**National Highways Authority of India**

**NHAI/PIU-RRK/66001/BM/Spur Haridwar/2021/6215**

**Sub:** Diversion of forest land for the development of 6-lane (greenfield) access-controlled spur to Haridwar UP/Uttarakhand Boarder near Manakpur Adampur village (Ch:19+070) to Manoharpur village (Ch: 50+090) in Haridwar district of Uttarakhand State.

**- Regarding compliance of EDS dated 21/07/2022.**

DGPS MAP FOR PROPOSED COMPENSATORY AFFORESTATION (CA) LAND FOR DEVELOPMENT OF 6-LANE (GREENFIELD) ACCESS-CONTROLLED SPUR TO HARIDWAR UP/UTTARKHAND BORDER NEAR MANAKPUR ADAMPUR VILLAGE (CH:19+070) TO MANOHARPUR VILLAGE (CH:50+090) IN HARIDWAR DISTRICT OF UTTARAKHAND STATE.

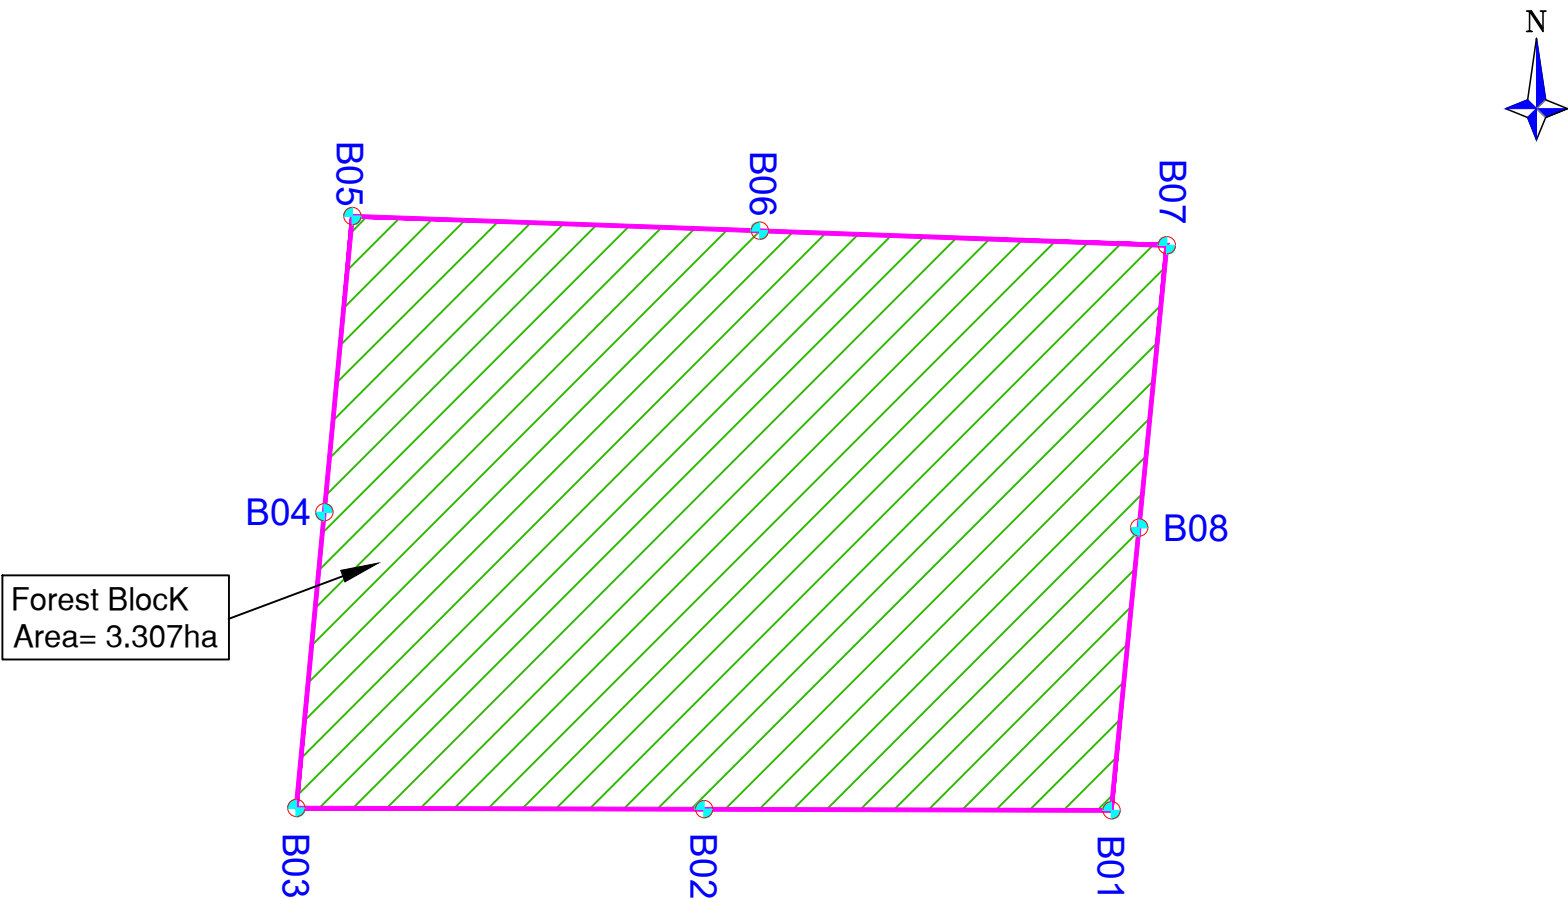
9	It is seen that the density is mentioned as zero at para 4 in part II. State Government is requested to submit the clarification in this regard.	State Government may please provide the necessary detail/ clarification.
10	The details of the working plan for the protected forest area is not uploaded at para 5 in part II. which is required to be done.	DFO/DCF may please provide the necessary detail.
11	Sol Toposheet and digital map for the area proposed for CA uploaded at para 13 in part II are not authenticated by any authority. Duly authenticated document is required to be submitted by the DFO.	Authenticated Sol Toposheet and digital map for the area proposed for CA has been attached and the same may please be uploaded by DCF/DFO.
